STEAM GENERATOR TUBE INSPECTION DISCUSSION DURING PALISADES 2015 (RF24) OUTAGE (Preliminary Information)

Currently Palisades is ~ 80% through the base scope eddy current inspection and starting the special interest as of 10/1/2015 at ~ 1200 hours

The following is the Primary to Secondary Leak Trend for the Last Fuel Cycle
Note: Units in Gallons per Minutes

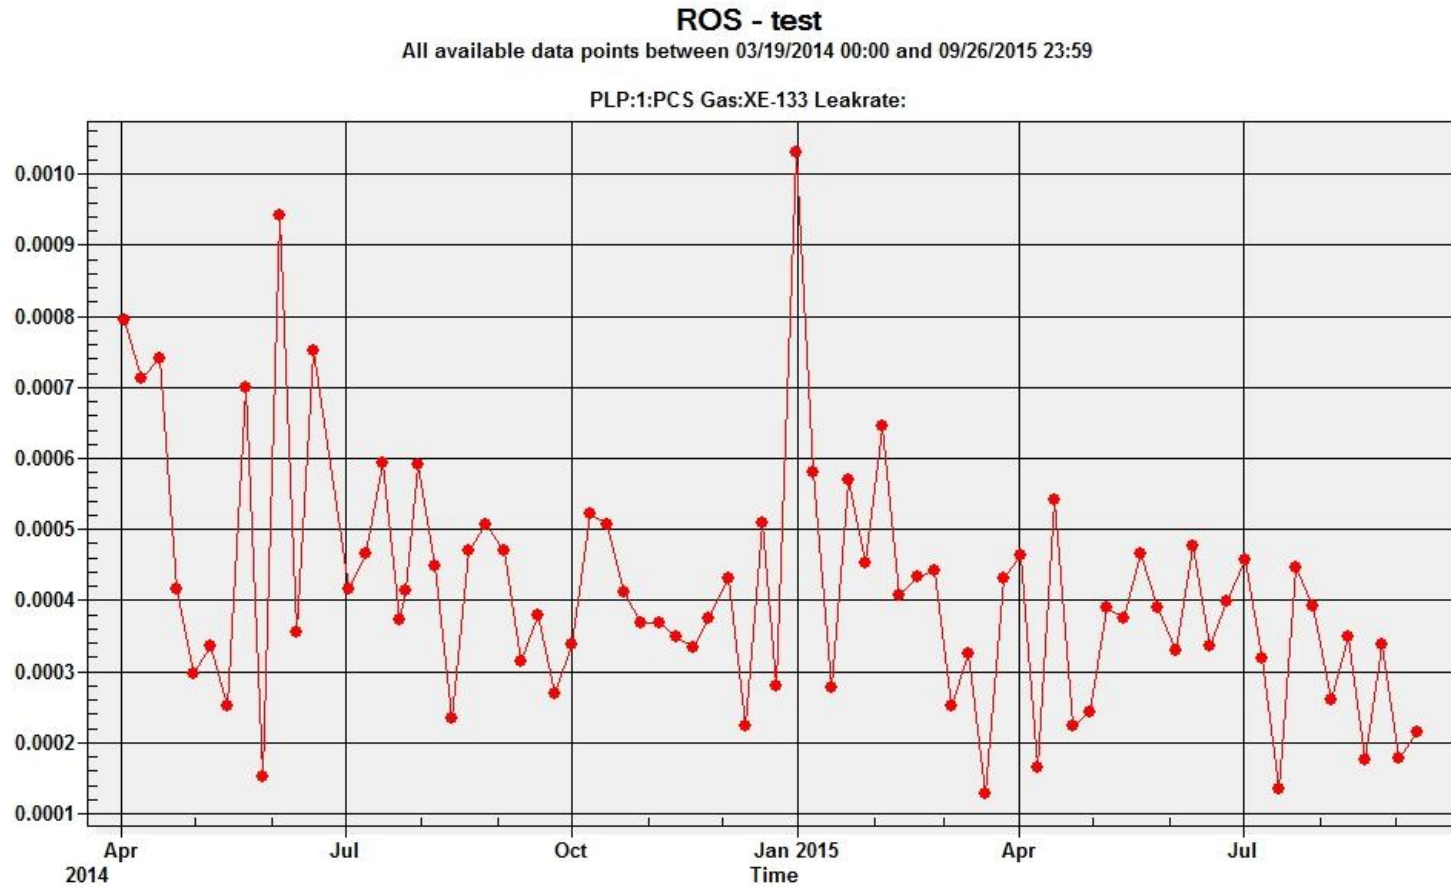
1. Discuss any trends in the amount of primary-to-secondary leakage observed during the recently completed cycle.

Refer to attached Primary to Secondary Leak Rate for Operational Cycle 24 Primary to Secondary Leak Rate graph. Leakage has been minimal all cycle.
